THM 4T65-E UPDATE HANDBOOK

INTRODUCTION THM 4T65-E UPDATE HANDBOOK

Figure 21

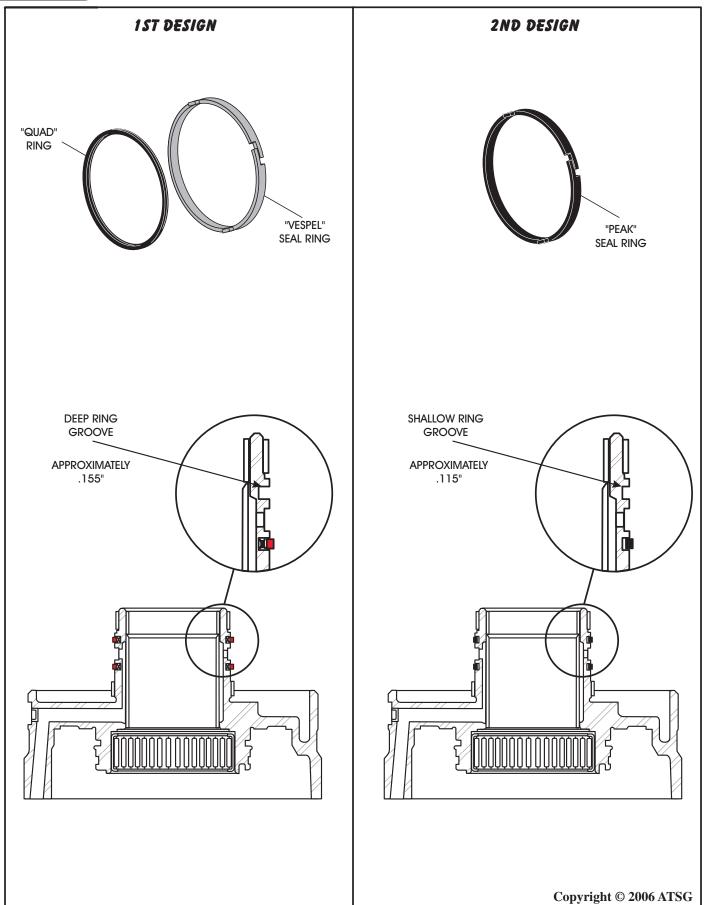
CHANGE: During the 1998 model year, and implemented as a running change, GM Powertrain eliminated the rubber "Quad-Ring" that was used as an expander for the Vespel sealing rings on the driven sprocket support, as shown in Figure 21. There was also a change of material for the sealing rings that occured at the same time. "Vespel" material was eliminated, and "Peak" material was implemented, as shown in Figure 21.

- (1) RUBBER QUAD-RING The rubber quad-ring, that was used in the seal groove under the "Vespel" seal ring as an expander, was eliminated (See Figure 21).
- (2) VESPEL SEALING RINGS The Vespel material sealing rings were replaced with a "Peak" material at the same time (See Figure 21). The "Vespel" seal rings are Brown in color, and the "Peak" seal rings are Black in color.
- (3) DRIVEN SPROCKET SUPPORT The seal ring grooves were not machined as deep on the second design sprocket support, to accommodate the new design seal rings without the rubber quad rings. The groove depth on 1st design is approximately .155", and groove depth on the 2nd design is approximately .115". Refer to Figure 21.

The second design driven sprocket support and the "Peak" 2nd clutch sealing rings will back service *all* previous models of the 4T65-E.

The first design driven sprocket support *must* be used with the rubber quad-rings.

Figure 22

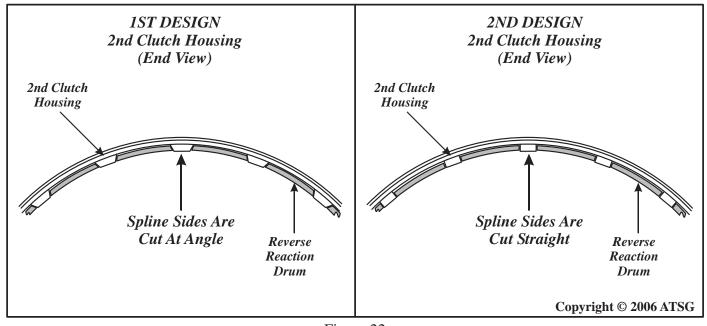
- (1) REVERSE REACTION DRUM Received some very slight dimensional changes on the splined end that enters the 2nd clutch housing. The sides of the slots that spline into the 2nd clutch housing were machined straight, as shown in Figure 22, and can be easily identified with the round holes stamped in the drum, as shown in Figure 23.
- (2) 2ND CLUTCH HOUSING Received some very slight dimensional changes on the internal splines, where the reverse reaction drum mates with the 2nd clutch housing. The sides of the splines in the 2nd clutch housing were machined straight, to accommodate the revised slots in the reverse reaction drum, as shown in Figure 22. There are no other means of identification on the 2nd clutch housing.

There is a Service Package that includes both parts, and is available from GM, under OEM part number 24213402

Figure 24

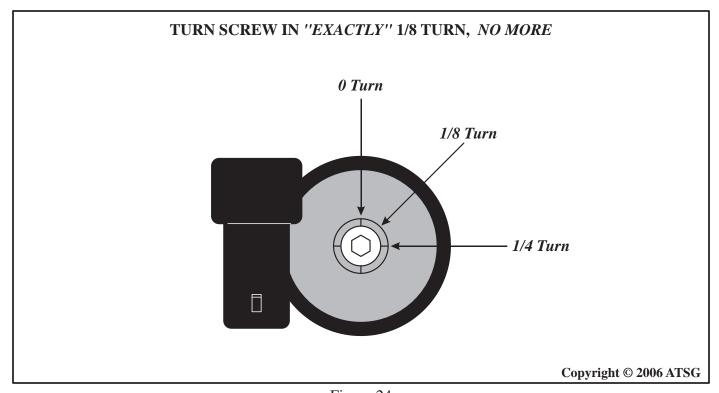
CORRECTION: Replace the Pressure Control Solenoid with the *updated* PCS, available from OEM under part number 10478146. Before installing the new PCS, turn the adjusting screw on the end of the solenoid in exactly 1/8 turn, as shown in Figure 24.

Figure 25

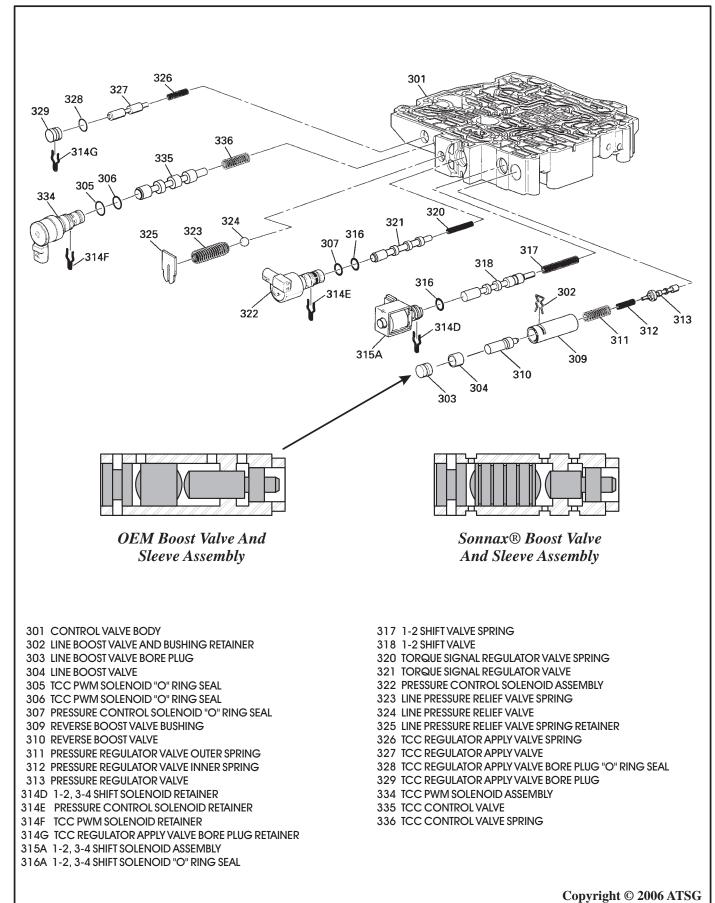
> Inspect and replace as necessary, the boost valve and sleeve assembly located in the valve body, in the location shown in Figure 25. This valve train is available from Sonnax®, under part number 84754-30K, and is not yet available from OEM except in a complete valve body assembly.

Figure 26

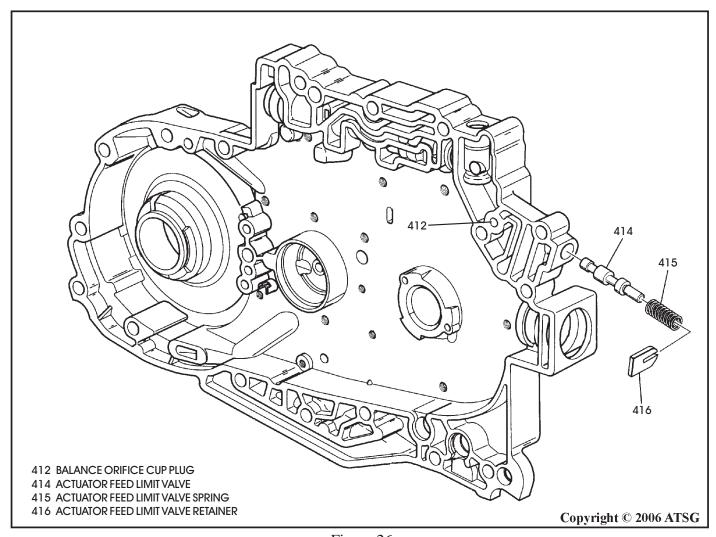
One cause may be a stuck Actuator Feed Limit Valve, located in the channel plate, as seen in Figure 26. With this valve stuck, solenoid feed oil to shift solenoid 1-2/3-4 is either blocked or has insufficient flow rendering the solenoid inoperable as if the solenoid failed in the stuck off position mechanically. Shift solenoid 2-3 is not fed with Actuator Feed oil allowing it to continue to function as designed and thereby causing only second and third gears to be available, irregardless of the proper shift commands being provided by the computer. Also, inspect the orifice cup plug (412), as shown in Figure 26, for any debris that may be clogging the orifice.

CORRECTION: Free the Actuator Feed Limit valve.

Figure 27

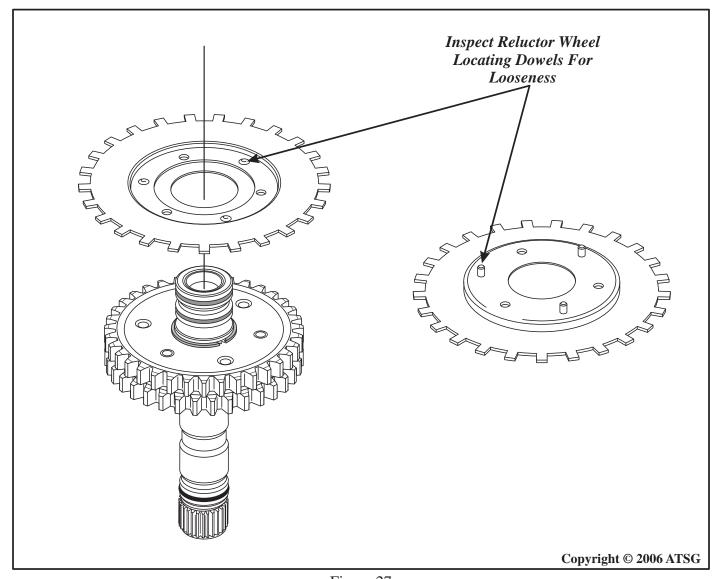
wheel. Refer to Figure 27.

CORRECTION: Replace the input speed sensor reluctor wheel with updated OEM part number 24212217.

Figure 28

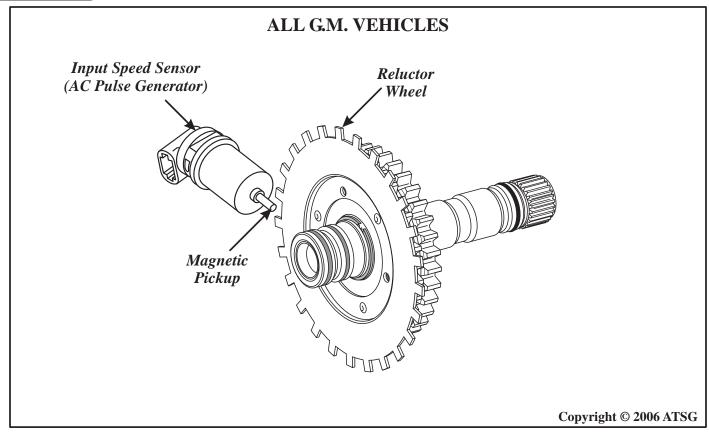
One cause may be, that an incorrect Input Shaft Speed Sensor was installed into the vehicle. All General Motors applications utilize an AC Pulse Generator as shown in Figure 28, while all Volvo applications use a two wire Hall Effect Sensor, as shown in Figure 29. Both will install into the channel plate and plug into the wire harness without incident. *These speed sensors will not interchange*.

Figure 31

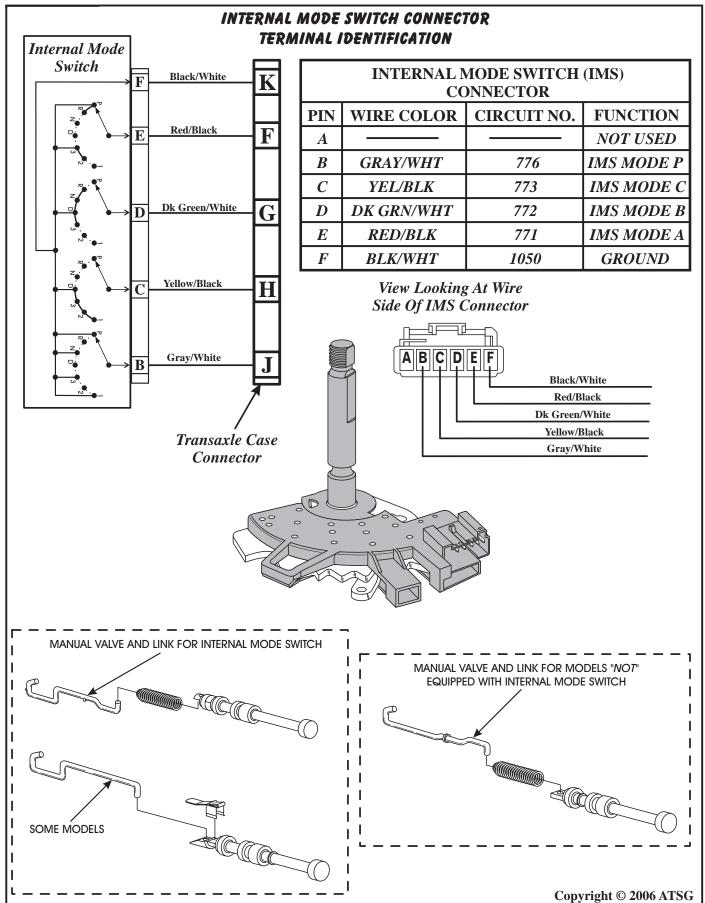
CHANGE: Beginning at the start of production for 1999, some models of the THM 4T65E were produced with an "Internal Mode Switch" (IMS). The transaxle Internal Mode Switch (IMS) is a sliding contact switch attached to the selector detent inside the transmission side cover, as shown in Figure 30. The four inputs to the PCM from the IMS indicate which position is selected by the transmission selector lever. This information is used for ignition timing, EVAP canister purge, EGR and IAC valve operation, as well as for starting functions when the selector lever is in P or N and proper ground is made. The state of each input is available for display on the scan tool. The four input parameters represented are Mode P, Mode A, Mode B and Mode C (Refer to Figure 31).

- (1) MODE SWITCH Now mounted internally instead of externally on the transaxle case, and applies to only *some* models (See Figure 30).
- (2) INTERNAL WIRE HARNESS Five wires added to the internal harness to accommodate the new mode switch that now run through the transaxle case connector (See Figure 31).
- (3) MANUAL VALVE LINK Was made shorter to accommodate the added internal mode switch, as shown in Figure 31. We have also included other model manual valve links for comparison.
- (4) MANUAL VALVE Was made longer to accommodate the added internal mode switch, as shown in Figure 31.

Figure 38

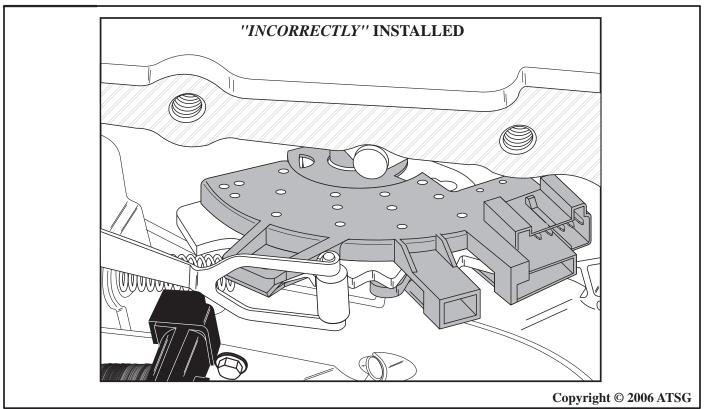
The new Internal Mode Switch also allows you to make an assembly error on the installation. Refer to Figure 38 for the most common "Incorrect" assembly, and refer to Figure 39 for the "Correct" assembly of the Internal Mode Switch. Refer to the description of the complaint below, when and if, you do install it wrong.

Figure 40

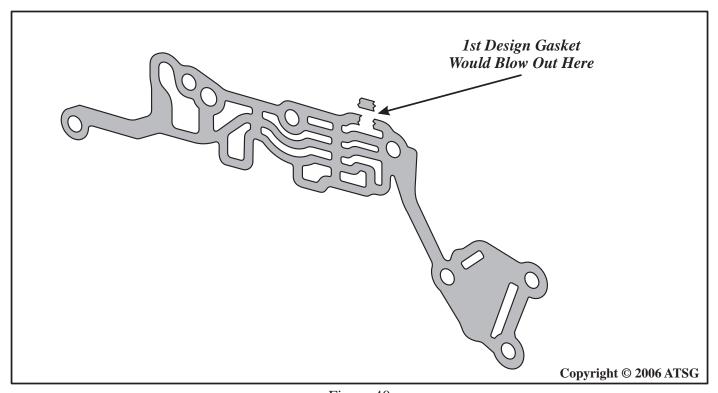
REASON: The 1st design gasket would "blow out", as illustrated in Figure 40, which would allow full line pressure to be aimed right at the vent, and this was not a good thing. The top passage was eliminated in the 2nd design gasket, as shown in Figure 41. Unfortunately, this created more concerns of gaskets blown out due to excessive pressure. This required the 3rd design gasket which now has 2 slots in this area, as shown in Figure 41.

Figure 41

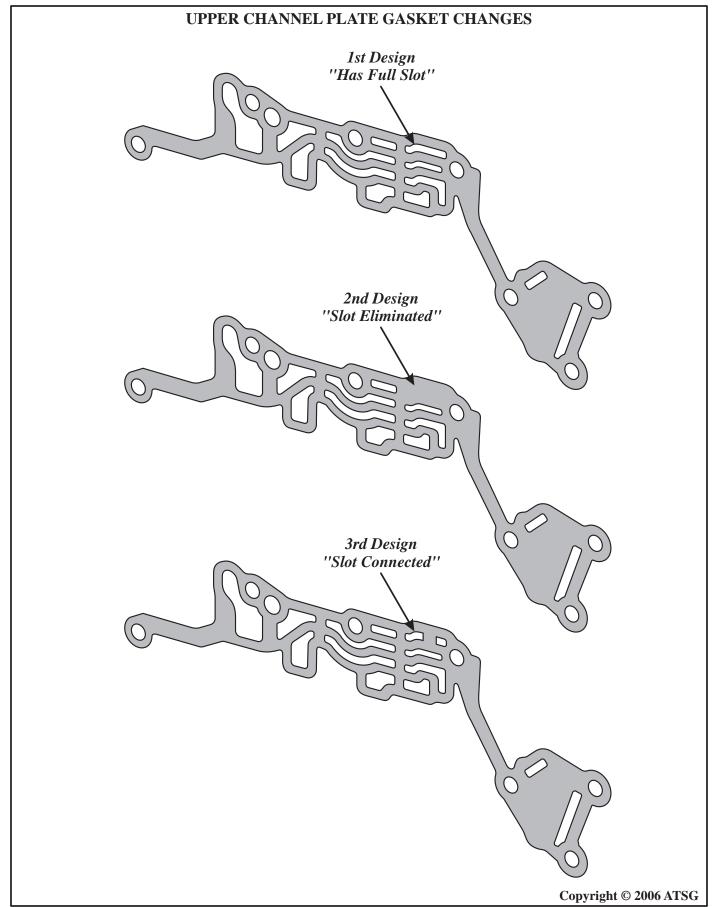
CHANGE: The upper channel plate gasket has now been changed twice which now creates three different design levels. All three design levels are illustrated in Figure 41.

(1) UPPER CHANNEL PLATE GASKET - In the 3rd design gasket GM engineering has added 2 slots to improve fluid flow, as shown in Figure 41.

This was a running change at the assembly plant, and the 3rd design gasket will replace all previous gaskets for all models (See Figure 41). The 3rd design gasket is now included in the aftermarket gasket sets.

Figure 42

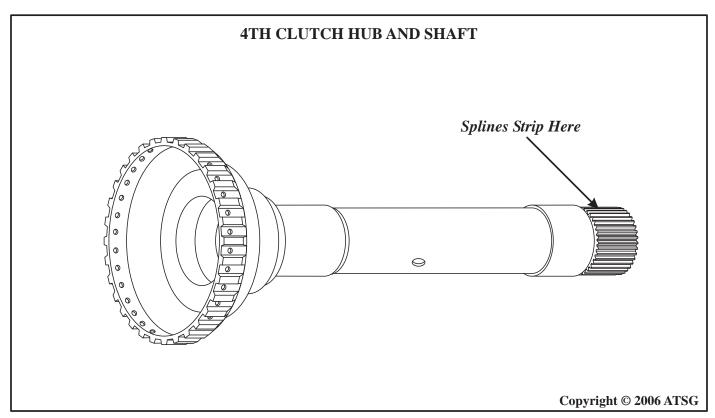
input sun gear, as shown in Figure 42.

Figure 47

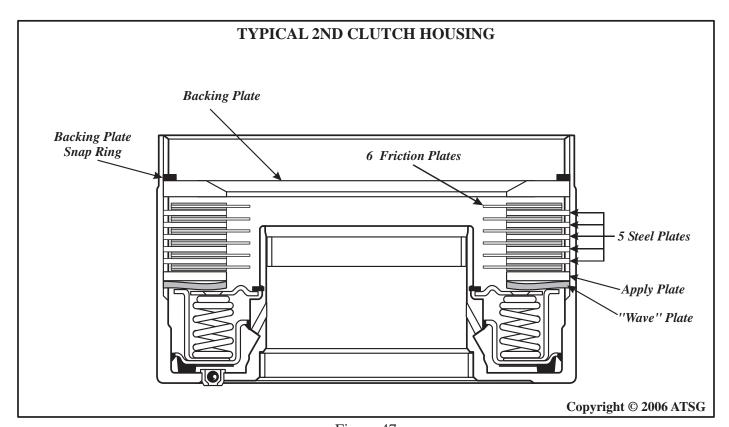
The 2nd clutch assembly has 6 friction plates, 5 steel plates and 1 wave plate, as shown in the housing cut-away in Figure 47. Referring back to the "general rule", this means that our preferred 2nd clutch clearance should be .048"-.072". The OEM steel plates are .068" thick. If the 2nd clutch clearance is .116" or more, adding an extra steel plate on top of the wave plate may be all that is needed to correct this concern.

Figure 48

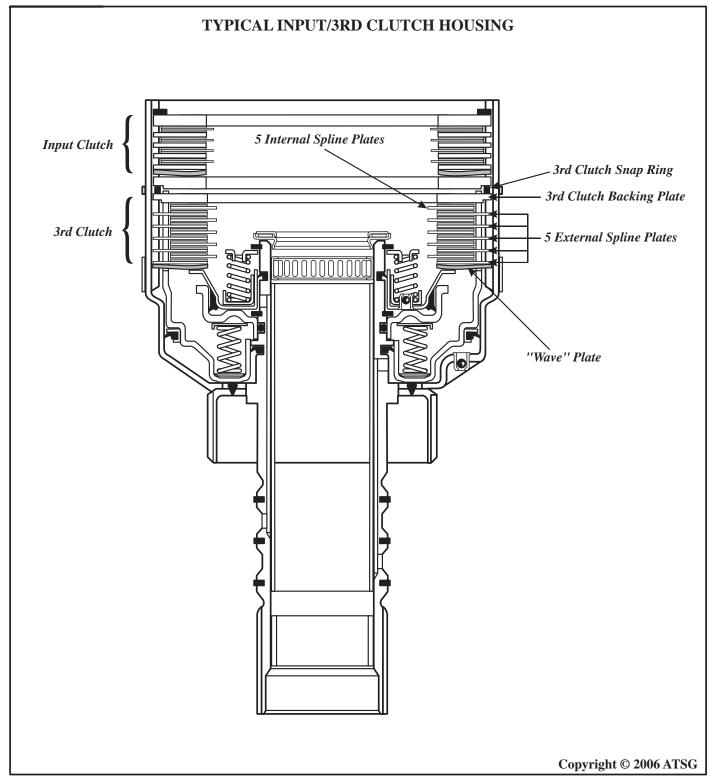
The 3rd clutch assembly has 5 "Single Sided" driving plates (external spline), and 5 "Single Sided" driven plates (internal spline), and 1 wave plate, as shown in the housing cut-away in Figure 48. Referring back to the "general rule", this means that our preferred 3rd clutch clearance should be .040"-.060". The OEM driving plates are .076" in total thickness with the steel core measuring .048". The OEM driven plates are .082" in total thickness with the steel core measuring .050". If the 3rd clutch clearance is .088" or more, you could remove the friction material from one extra external spline driving plate and place it on top of the wave plate first, and then add the normal stack of drive and driven "Single Sided" plates.

Figure 49

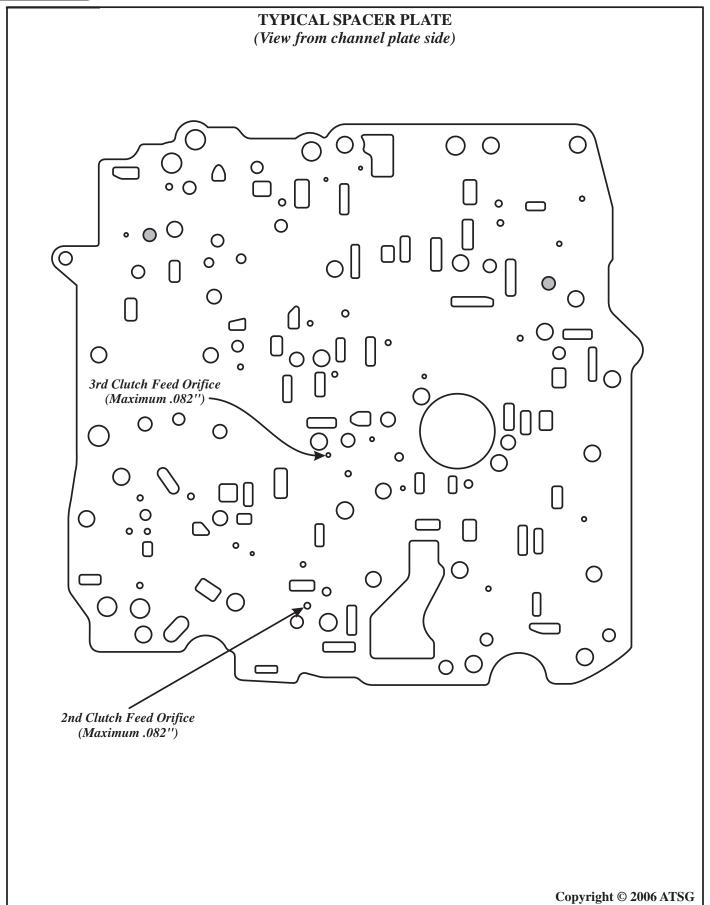
Further modification to the valve body spacer plate can also be made to allow the 2nd clutch and 3rd clutch cavities to fill quicker. Opening the 2nd and/or 3rd clutch feed orifices in the spacer plate .010" larger than original, as shown in Figure 49, will also allow a larger volume of oil the the clutch pack. The original orifice size is .070".

Special Note: Spacer plate orifice modification is not a recommended procedure as part of a normal overhaul. This should be considered as an option, only after all other possibilities have been eliminated. Never exceed .082" total orifice size.

Figure 50

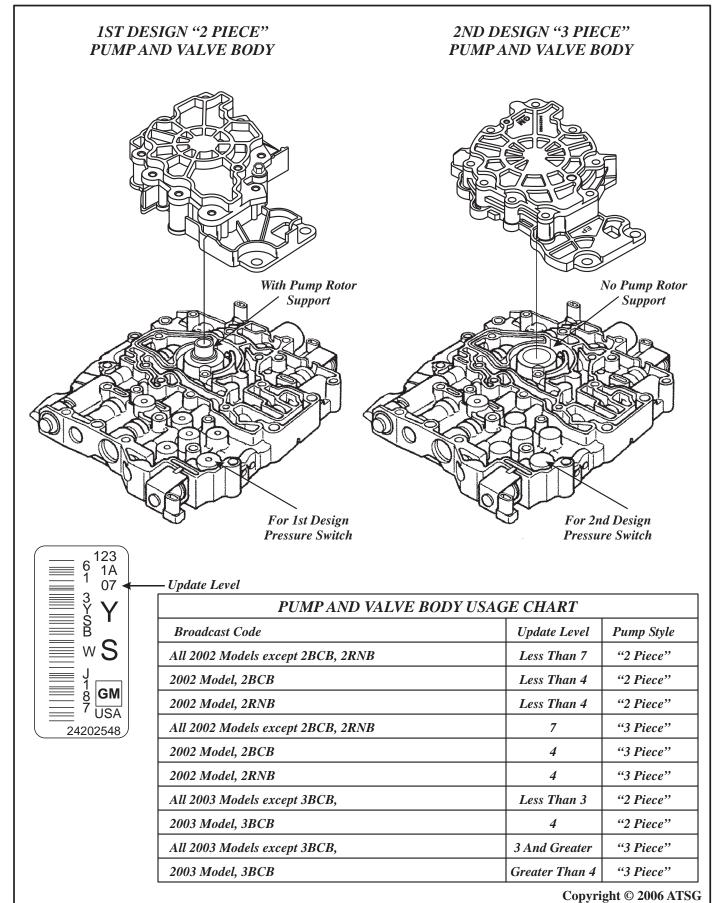
> A physical inspection of the I.D. Tag will be *mandatory*, to obtain the update level, before ordering components for these transaxles. Refer to Figure 50 for the location of the update level on the I.D. Tag and a usage chart for design level of pump assembly.

- (2) OIL PUMP ASSEMBLY RETAINING BOLTS Are a different length than the previous design level oil pump bolts.
- (3) VALVE BODY ASSEMBLY The pump rotor support sleeve has been removed from the valve body to accommodate the "3 Piece" design level pump assembly, as shown in Figure 50.

Figure 51

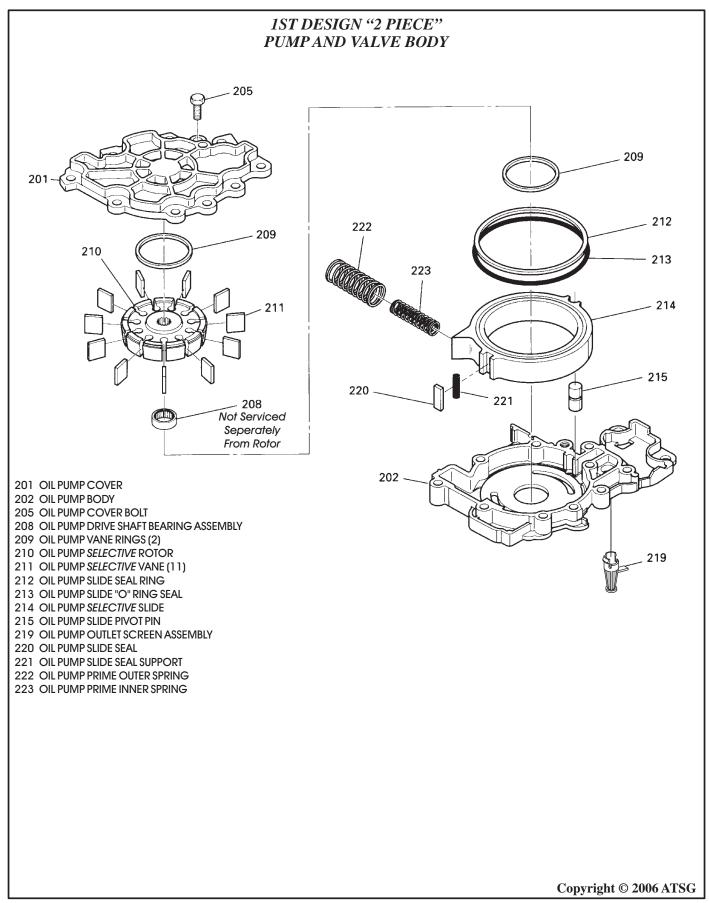
CHANGE: Beginning in June of 2002 Hydra-matic changed the design of the Oil Pump Assembly on 2002 and 2003 models of the 4T65-E transaxles. The "2 Piece" design level pump has been changed to a "3 Piece" design and has affected many of the related parts. The "2 Piece" design level pump is illustrated in Figure 51 and the "3 Piece" design level pump is illustrated in Figure 52.

- (1) OIL PUMP ASSEMBLY Changed to a "3 Piece" design, as shown in Figure 52. The "3 Piece" design now incorporates the rotor support sleeve in the pump instead of the valve body. The previous design "2 Piece design level pump is illustrated in Figure 51.

Figure 68

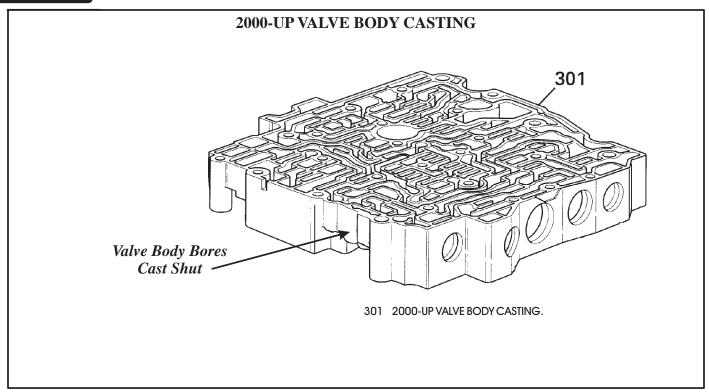
- (1) SERVO BOOST VALVES Complete valve trains eliminated, as shown in Figure 68.
- (2) VALVE BODY CASTING Servo boost valve bores are now cast shut, as shown in Figure 68.

Figure 69

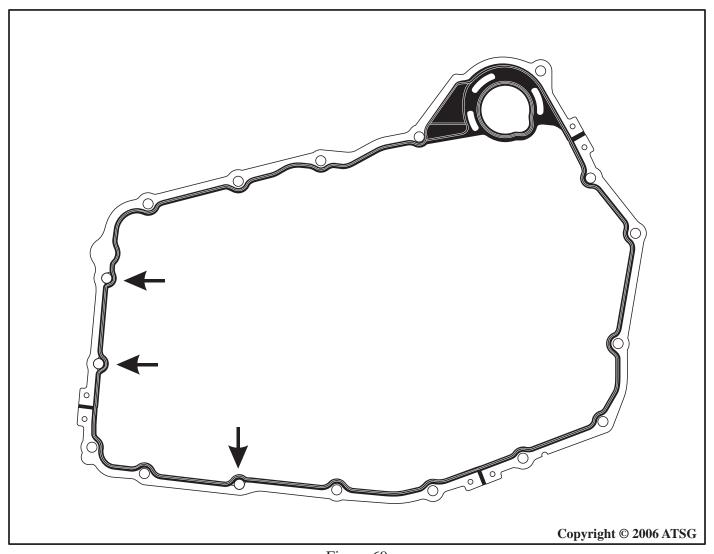
gasket, in Figure 69.

Explanation: The three gasket bolt hole locations, shown in Figure 69, do not have any metal support around the inside perimeter of the gasket, on the side the arrows are on. This allows zero support on the inside perimeter, and if overtorqued, will crack the structural side cover,
